STAFF ANALYSIS

Case No.:	SLUP-21-1244249	Agenda #: N-12
Location/ Address:	Northwest corner of Rockbridge Road and Mountain Park Trail at 5942 Rockbridge Road in Stone Mountain, Georgia.	Commission District: 4 Super District: 7
Parcel ID:	18 035 01 001	
Request:	For a Special Land Use Permit (SLUP) in the R-100 (Single-Family Residential) District to construct a Place of Worship and an accessory skills development center, international visitor guest house, gymnasium, educational garden, groundskeeper quarters, and religious education facilities.	
Property Owner:	Chinagozi Sarah Ugwu	
Applicant/Agent:	Casswell Design Group	
Acreage:	3.001 acres	
Existing Land Use:	Two vacant residential structures	
Surrounding Properties:	Single-family homes to the north, east, south, and west.	
Adjacent Zoning:	North: R-100 South: R-100 East: R-100 West: RSM and R-100	
Comprehensive Plan:	SUB (Suburban) Consistent <input checked="" type="checkbox"/>	Inconsistent <input type="checkbox"/>

Staff Recommendation: FULL CYCLE DEFERRAL

SHEET TITLE
SLUP CONCEPTUAL BUILDING ELEVATION PLAN
 PROJECT
 STONE MOUNTAIN SKILLS DEVELOPMENT &
 YOUTH MINISTRY CENTER (SEED) POWERMENT
 FOR OKEY UGWU
 THE NONPROFIT ORGANIZATION FOR LEADERSHIP INSTITUTE, INC.
 EDUCATION AND LEADERSHIP INSTITUTE, INC.
 5942 Rockbridge Rd Stone Mountain, GA 30087

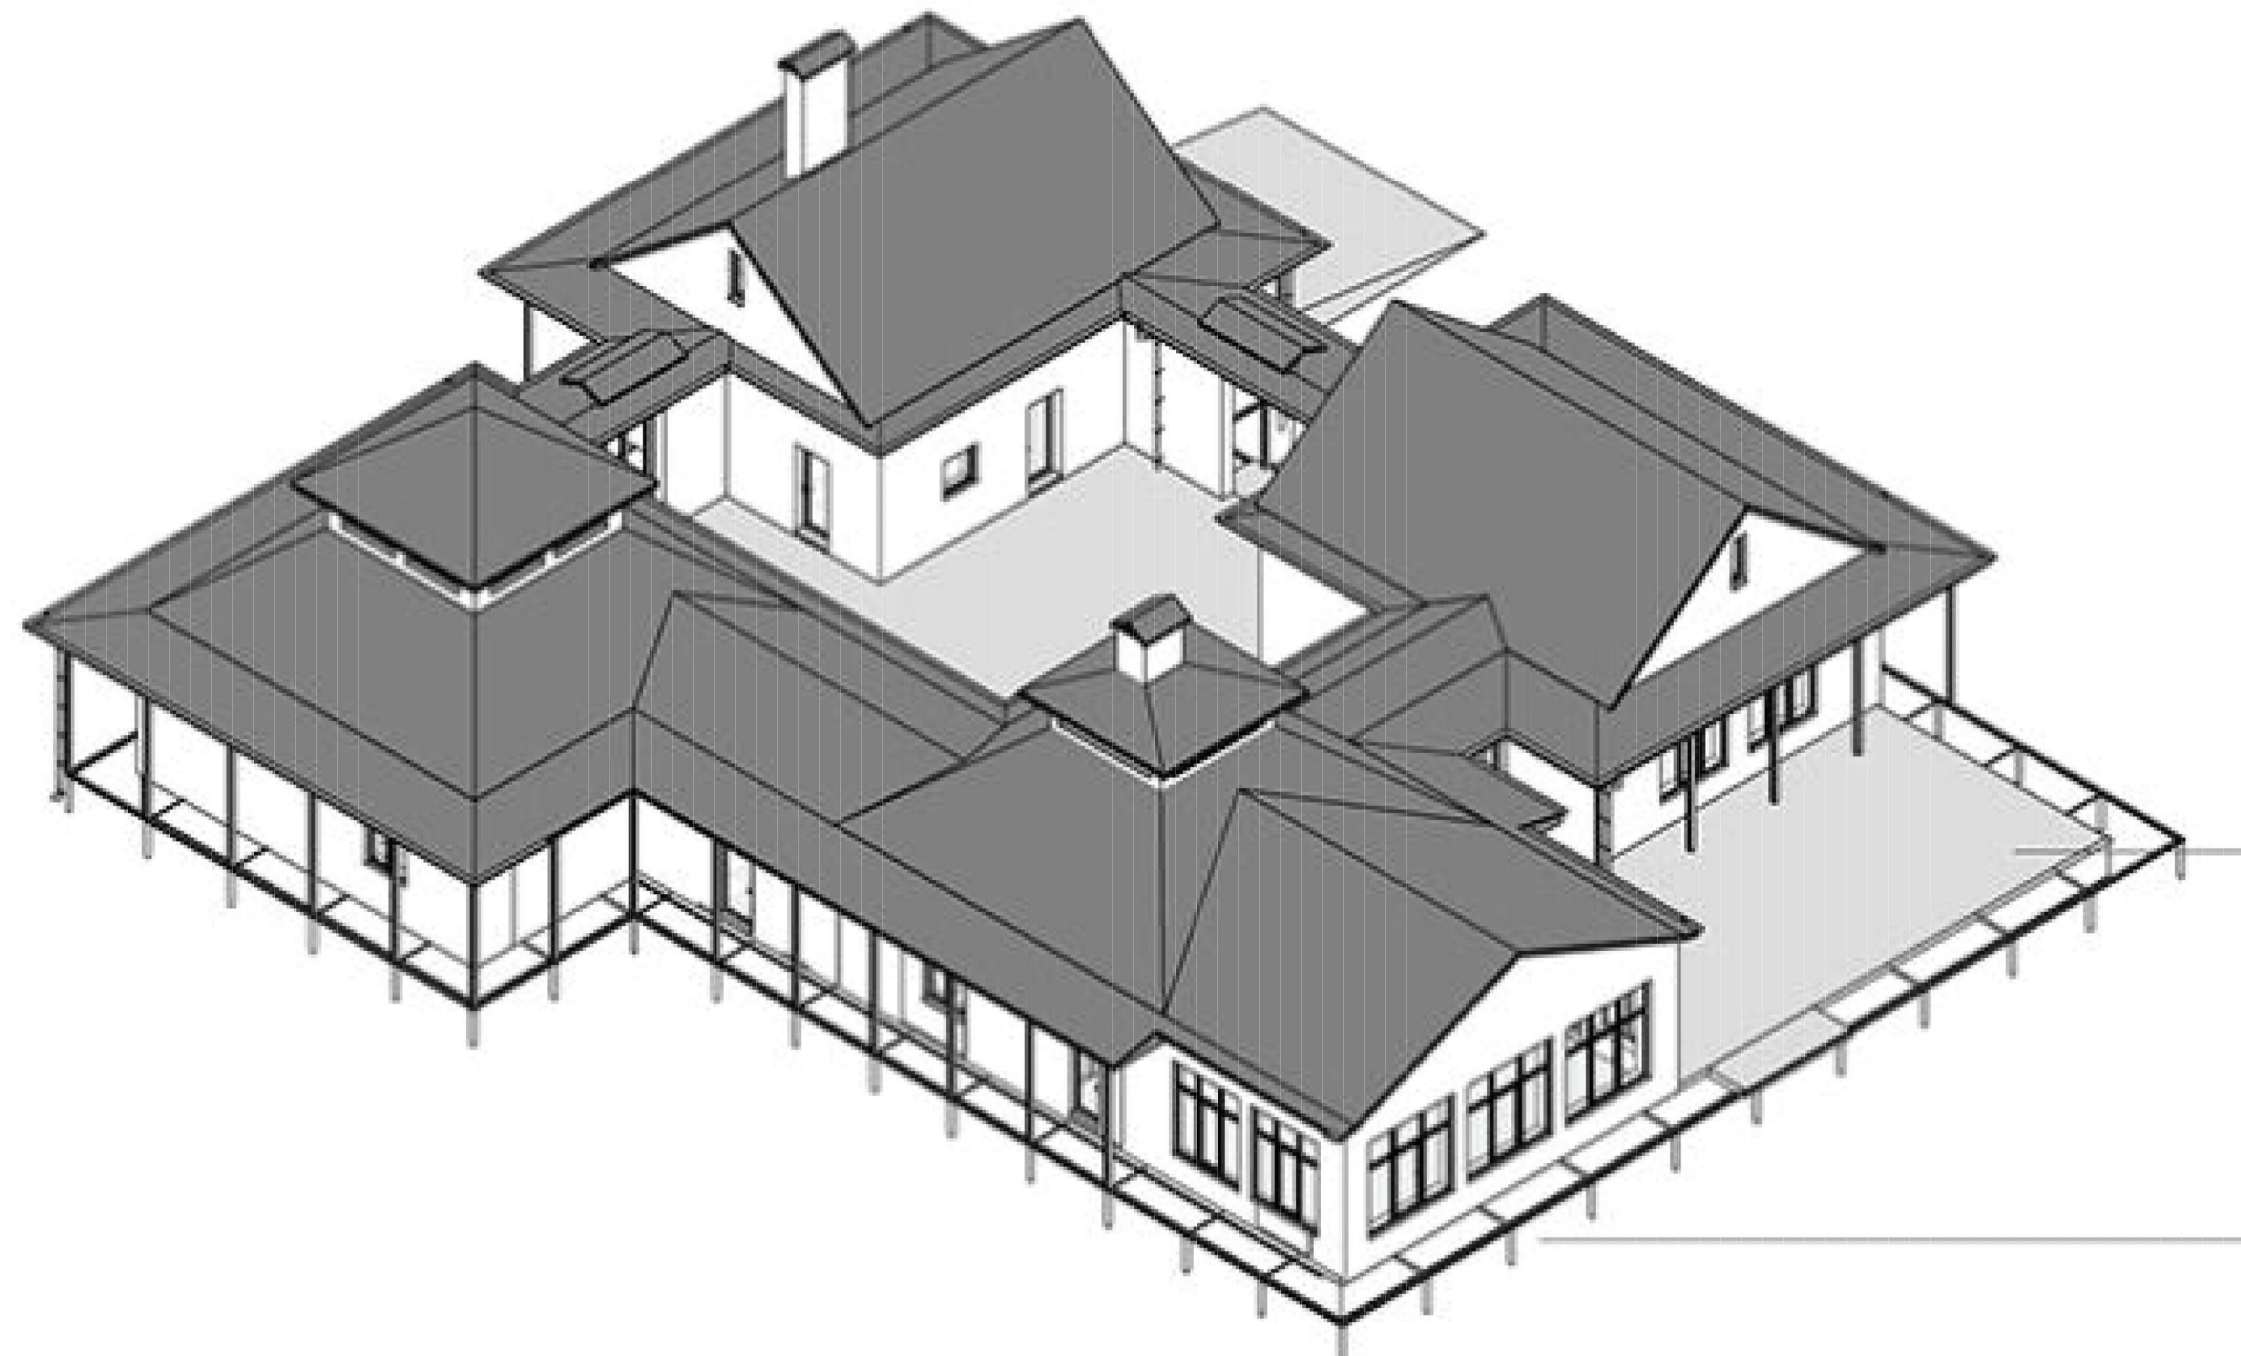
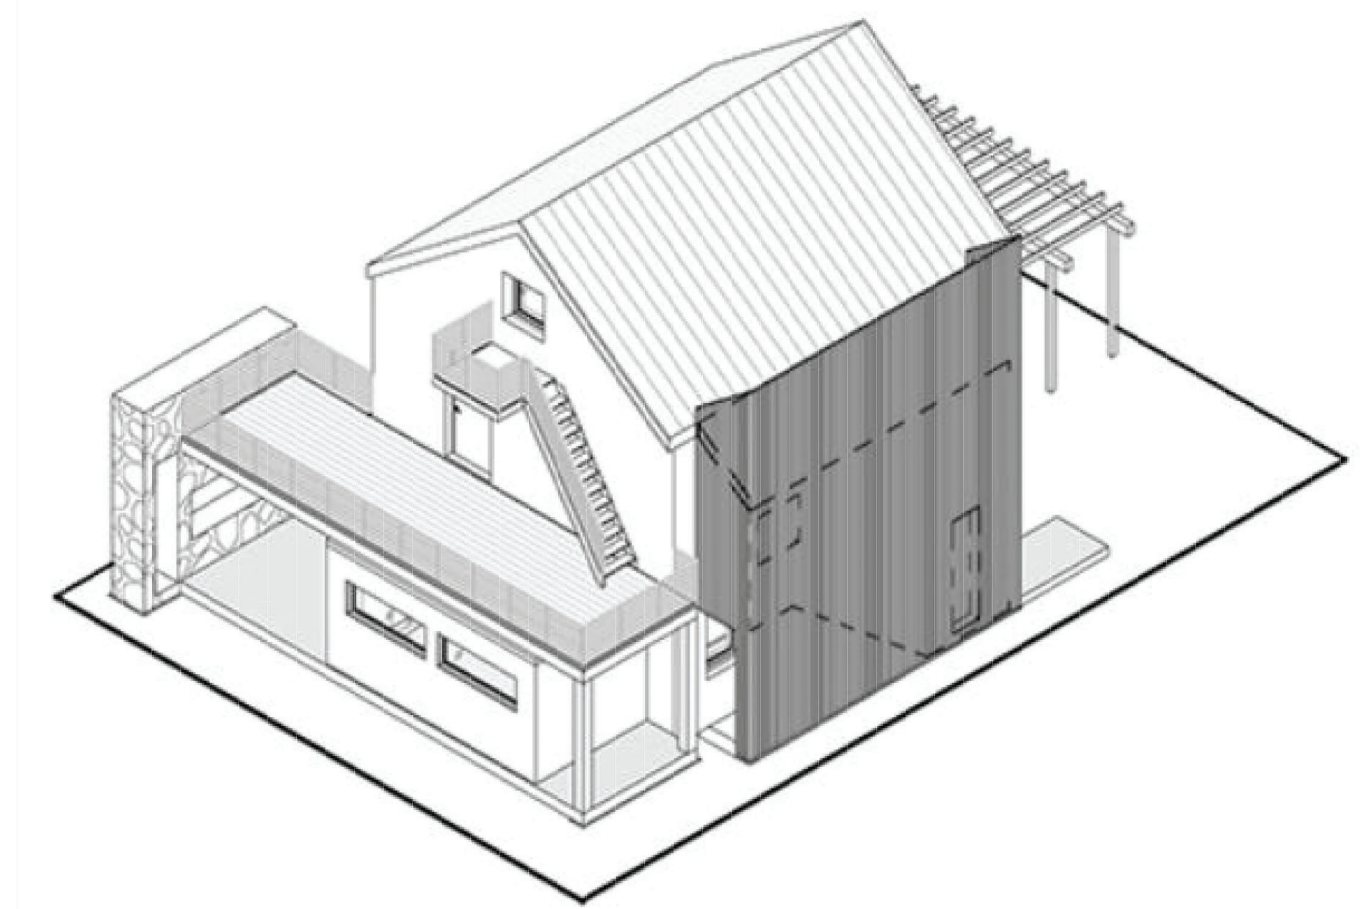
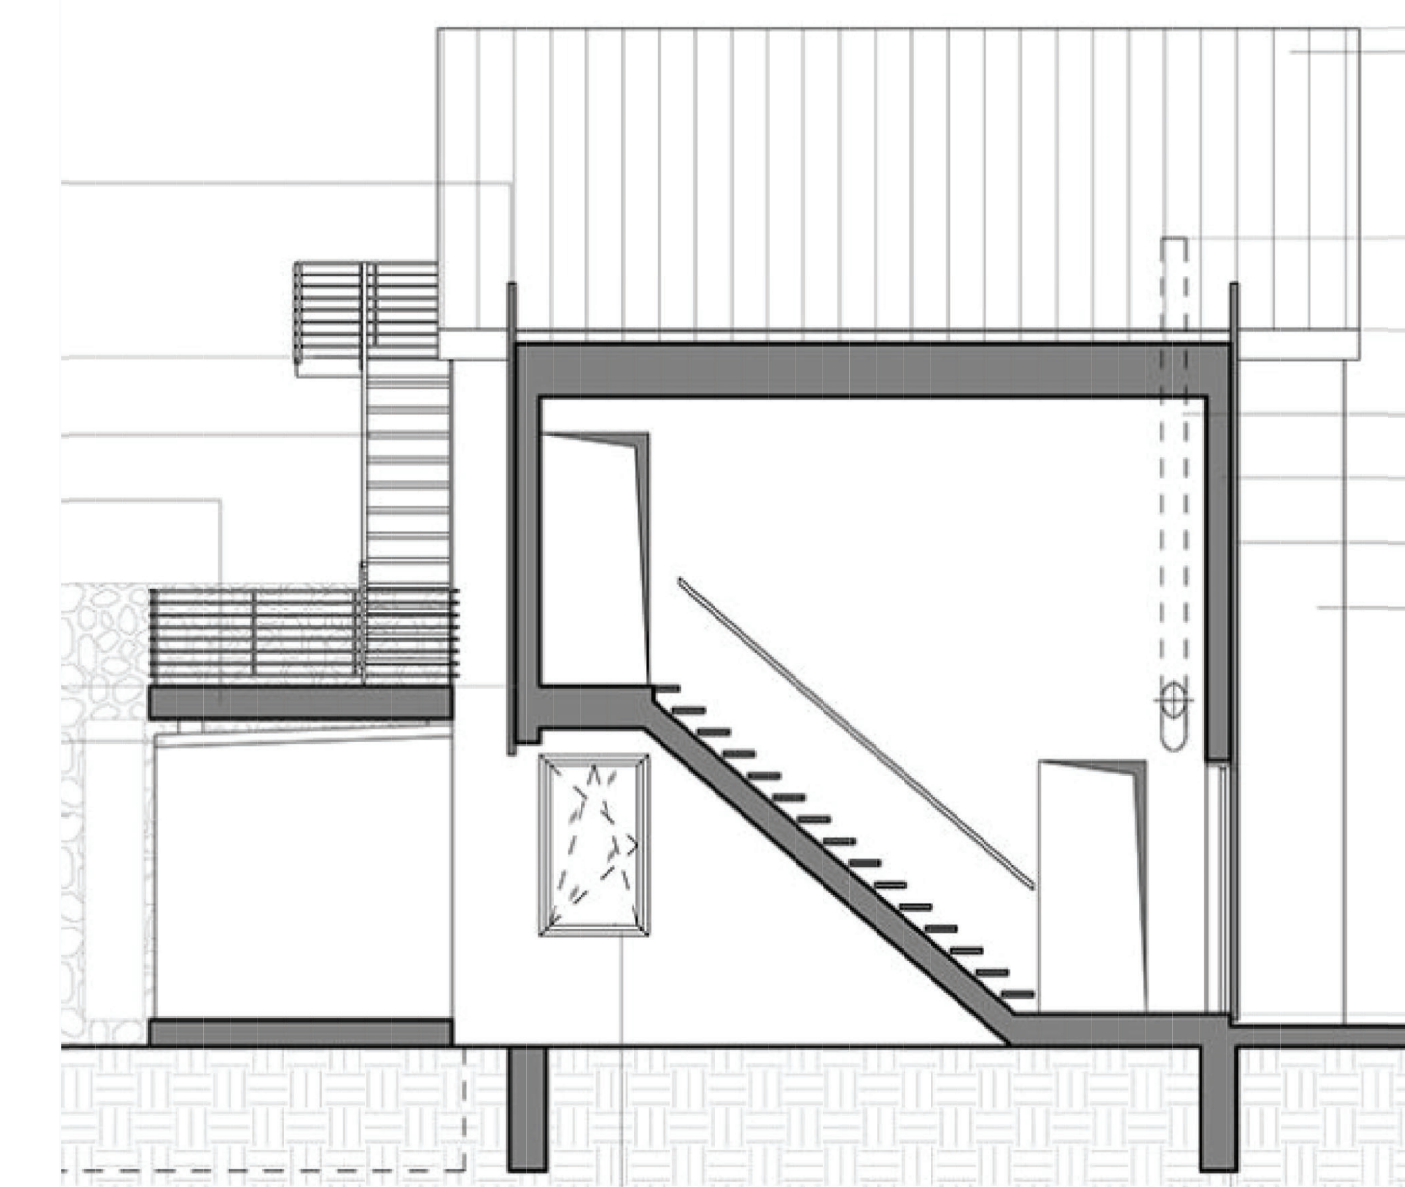
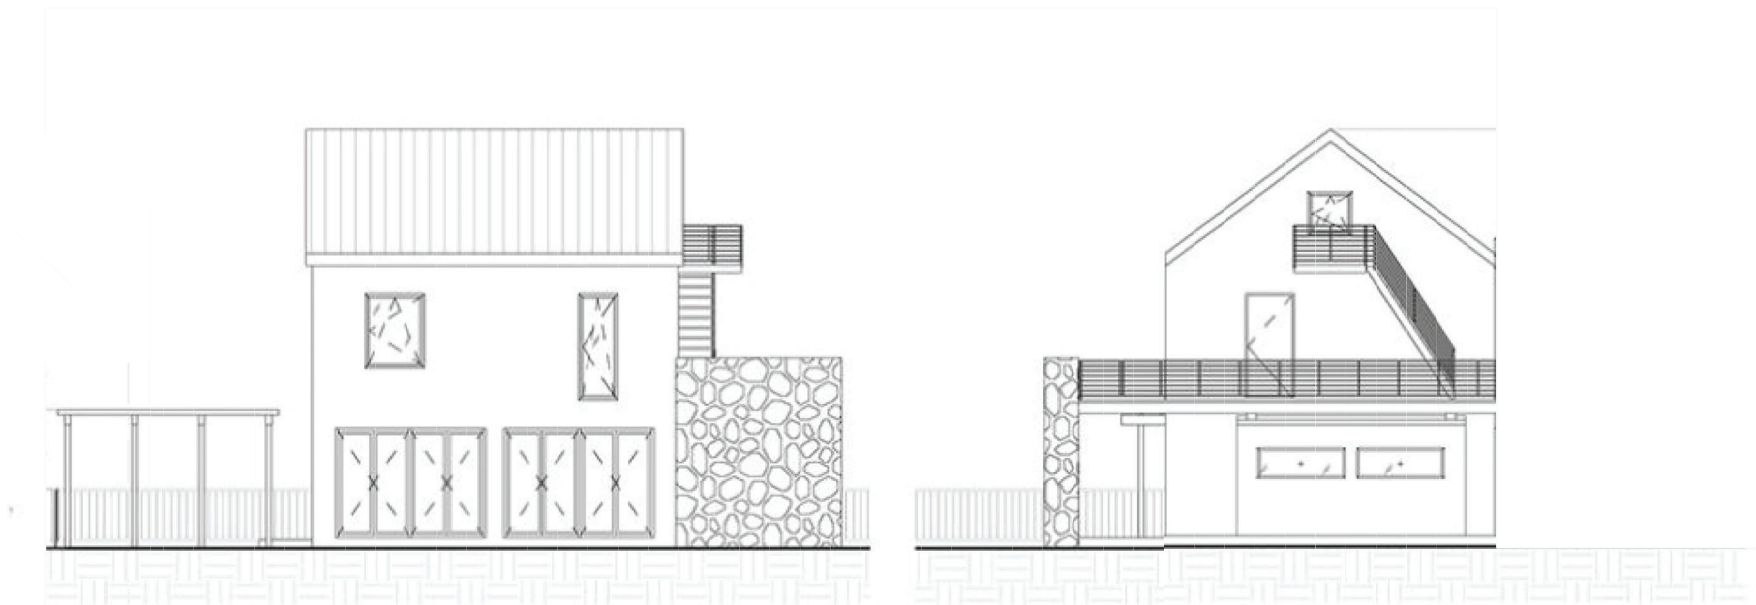
The proposed church and accessory buildings are a maximum of two-stories tall, with most of the proposed structures at a height of one-story (see attached conceptual elevations). These building heights are consistent with the one and two-story building heights of the single-family homes in the surrounding area. Additionally the proposed project complies with the Supplemental Regulations requiring that all buildings be located at least 50 feet away from property lines which abut residential uses. Therefore, there are no impacts on the size, scale, and massing of adjacent and nearby lots and buildings.

The proposed church and accessory buildings are a maximum of two-stories tall, with most of the proposed structures at a height of one-story (see attached conceptual elevations). These building heights are consistent with the one and two-story building heights of the single-family homes in the surrounding area. Additionally the proposed project complies with the Supplemental Regulations requiring that all buildings be located at least 50 feet away from property lines which abut residential uses. Therefore, there should be no negative shadow impact on any adjoining lot or building.
